# PLATEAU MINING COMPANY

Re: NOV 84-4-1-1 Permanent Abatement Plan **DIVISION OF OIL, GAS & MINING**

Enclosed please find a drawing showing our proposed Permanent Abatement Plan for NOV 84-4-1-1.

PERMANENT ABATEMENT PLAN

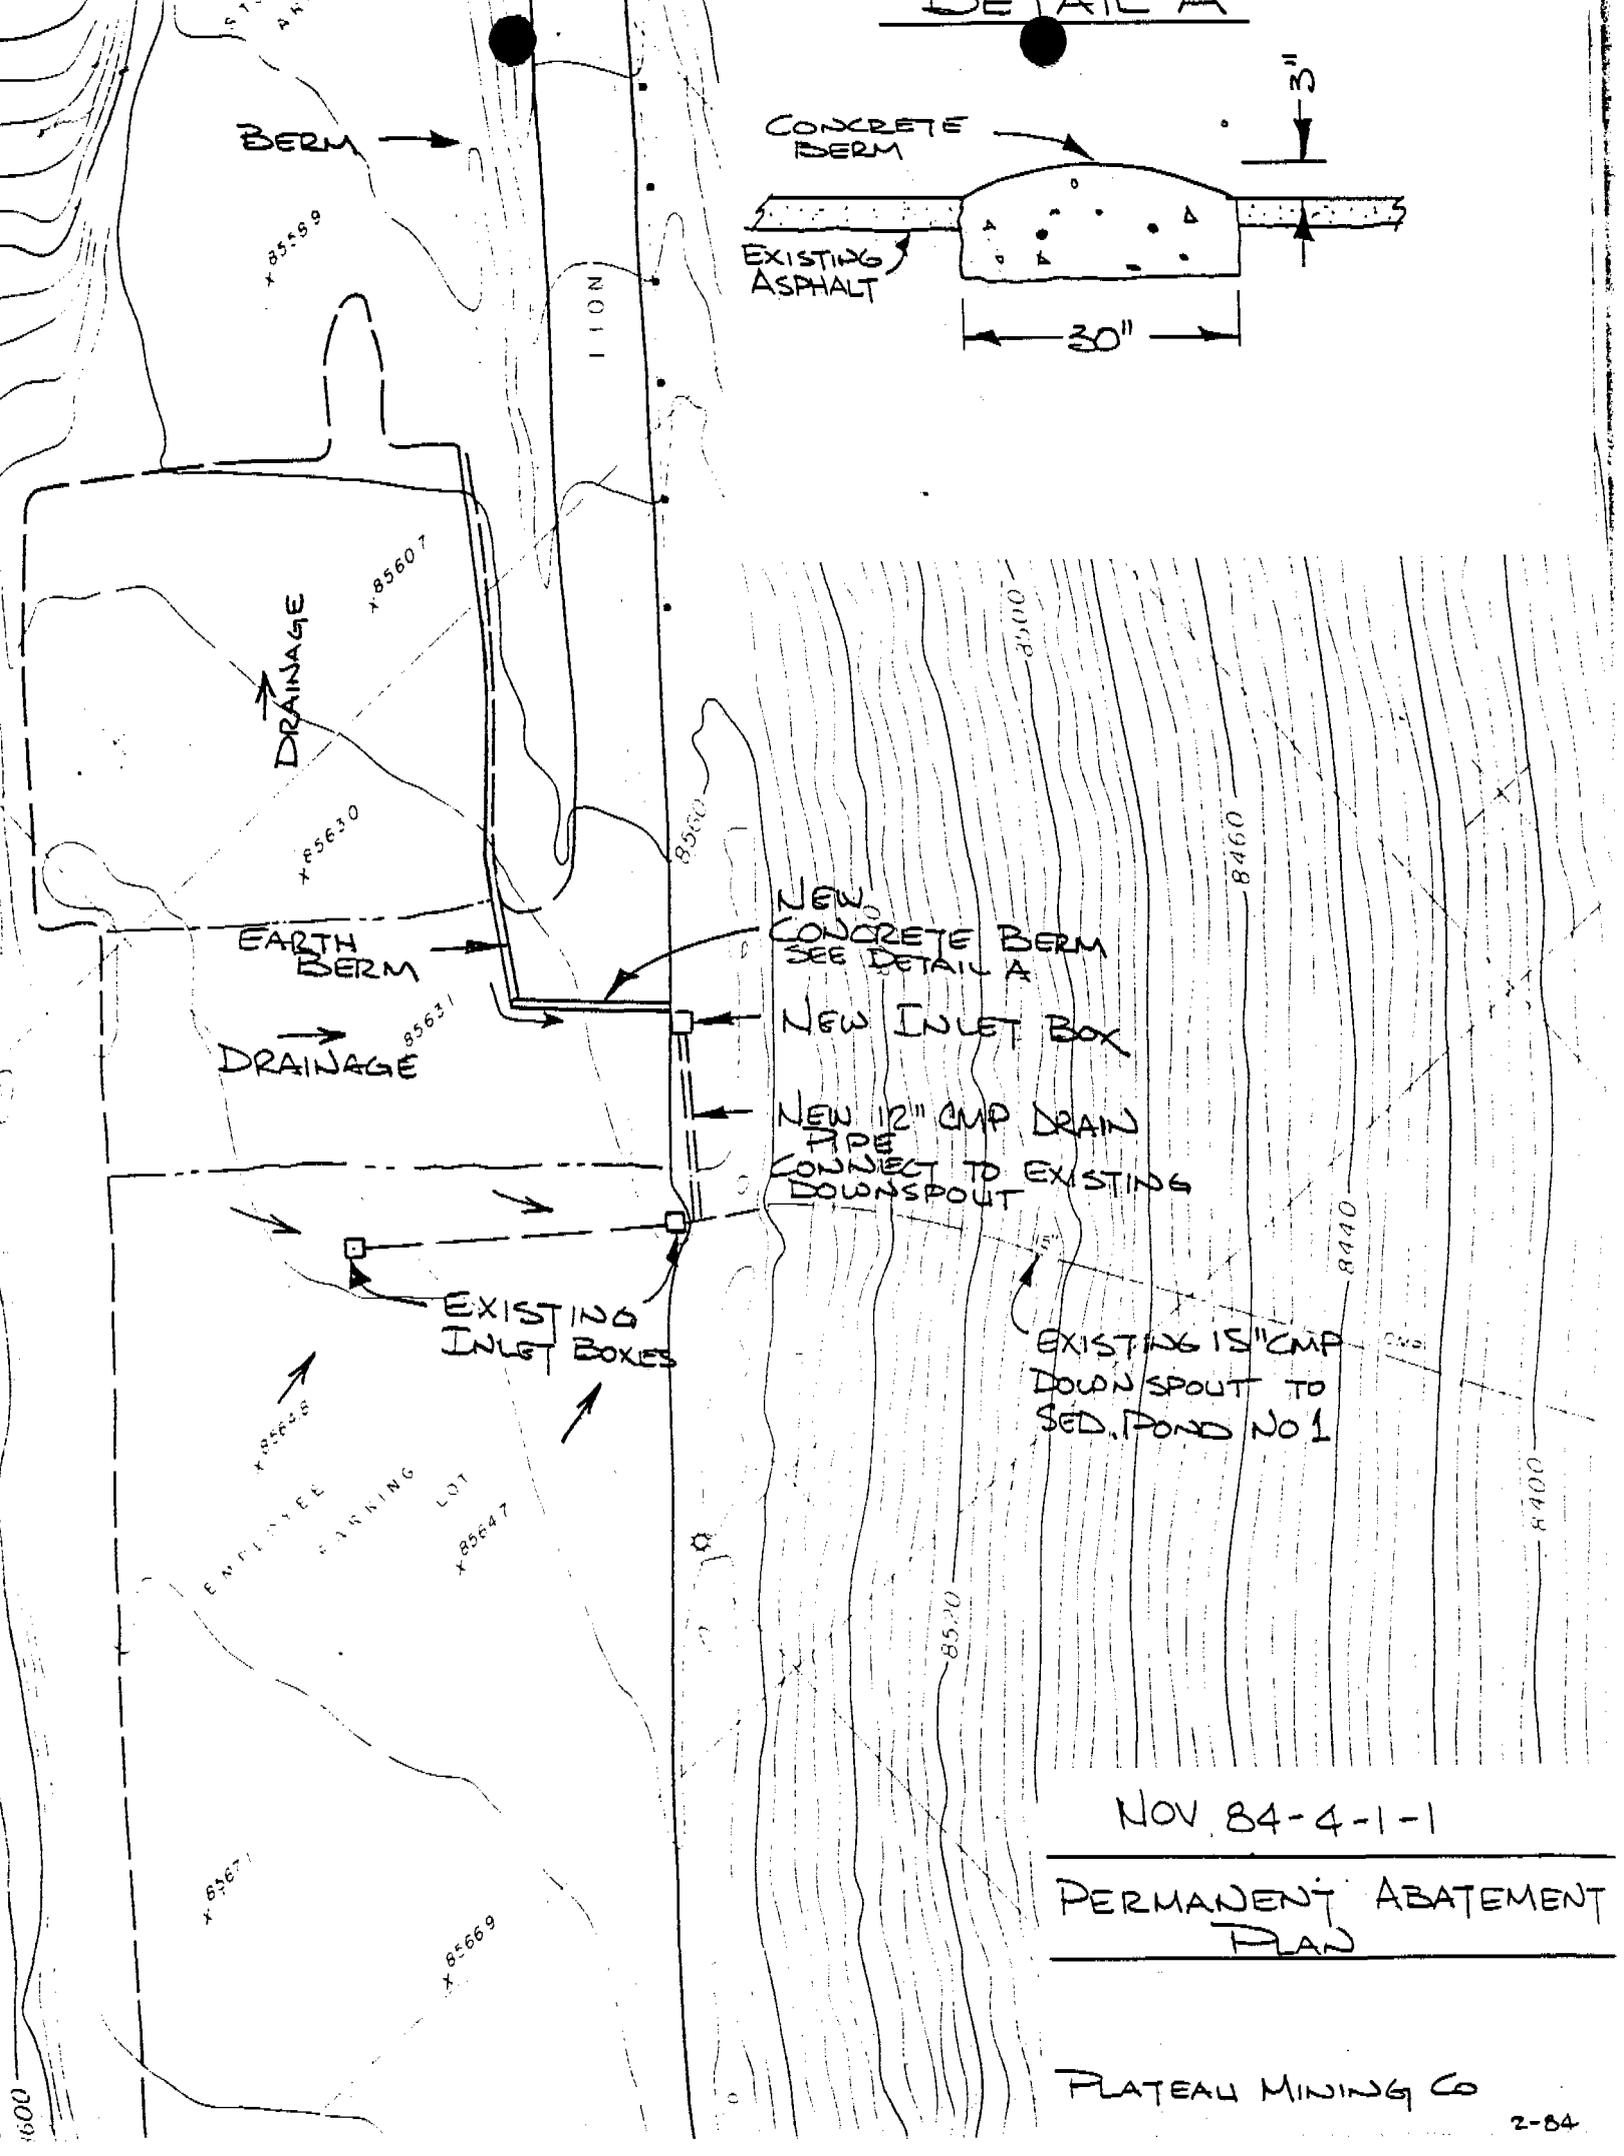
The contributing drainage area to the new inlet box and 12-inch pipe is 0.20 acres.

A 12-inch pipe at a slope of 4 percent with inlet control will carry 3.7 cfs minimum. The entire operation area in which this small drainage area lies contributes 3.72 cfs to Sediment Pond No. 1. Therefore, a 12-inch pipe is more than adequate to handle the runoff from this small area.

A concrete berm, as shown in Detail A on the enclosed Plan, will be constructed to prevent runoff from running down the road and divert it to the new inlet box. From the new inlet box, the runoff will flow through a new 12-inch cmp to an existing downspout which runs into Sediment Pond No. 1.

The contributing area was included within the Sediment Pond No. 1 drainage area and adds no additional flow to that pond.
